Consumers Power Company Palisades Plant Docket 50-255

PROPOSED TECHNICAL SPECIFICATION CHANGED PAGES, REVISION 1

PROPOSED TECHNICAL SPECIFICATIONS MARKED UP PAGE CHANGES

Figure 6.2-2

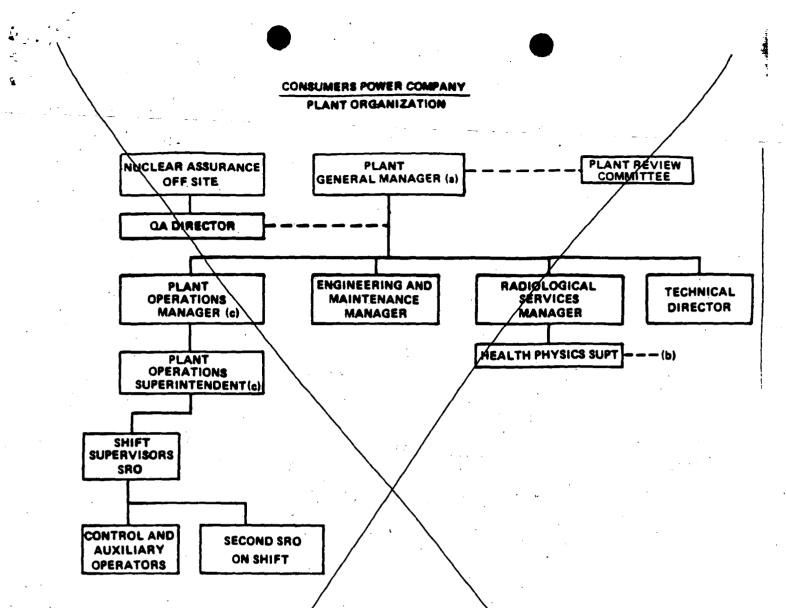
Added

- A. To support the above Plant organization, individuals knowledgeable in the following areas identified in ANSI N18.7-1976/ ANS 3.2 will report at the discretion of the Plant General Manager:
 - 1. Nuclear Power Plant Mechanical, Electrical and Electronic Systems
 - 2. Nuclear Engineering
 - 3. Chemistry and Radiochemistry
 - 4. Radiation Profection (Reports to Health Physics Superintendent)

- (a) Responsible for the Plant Fire Protection Program implementation.
- (b) A Radiation Safety Manager (RPM as defined in Regulatory Guide 1.8) shall be designated by the Plant General Manager and shall be either the Radiological Services Manager or the Health Physics Superintendent. The Radiation Safety Manager shall have direct access to the Plant General Manager in the matters of radiation safety.
- (c)Either the Plant Operations Manager or the Plant Operations Superintendent will hold an SRO License and meet the other requirements of 6.3.1 of these Technical Specifications (as applicable to Operations Manager in ANSI N18.1). The individual holding an SRO License shall be responsible for directing the activities of licensed operators.
